Rider 970

We have on some machines noticed breakage on the lifting cable 506 87 03-01.

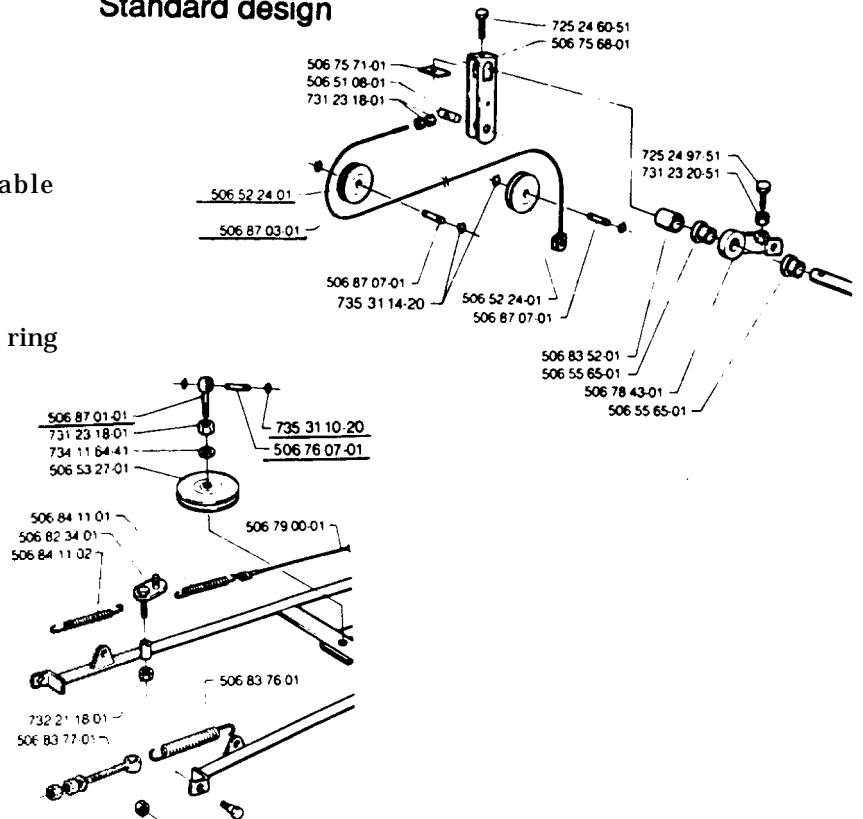
This is due to that cable wears on the plate to the chassis at the inlet above the attachment in the tool frame. This occurs when mowing with a slack cable.

Standard design

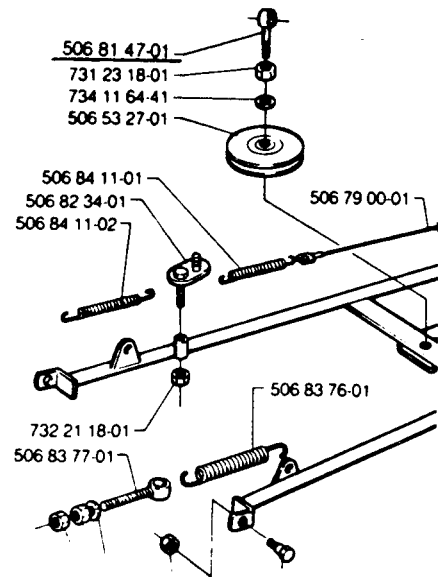
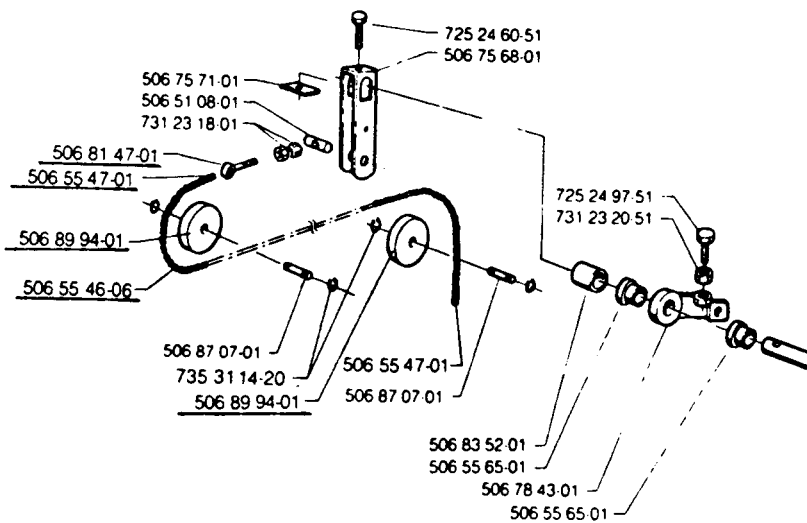
In order to remedy this problem we have introduced a roller chain which replaces the cable.

When mounting the chain, new pulleys and new eye bolts are required.

- 1 pc 506 55 46-06 Roller chain
- 2 pcs 506 89 94-01 Pulley
- 2 pcs 506 81 47-01 Eye bolt
- 2 pcs 506 55 47-01 Chain lock

On machines with frequent problems with the lifting cable, it is advisable to change to this chain.
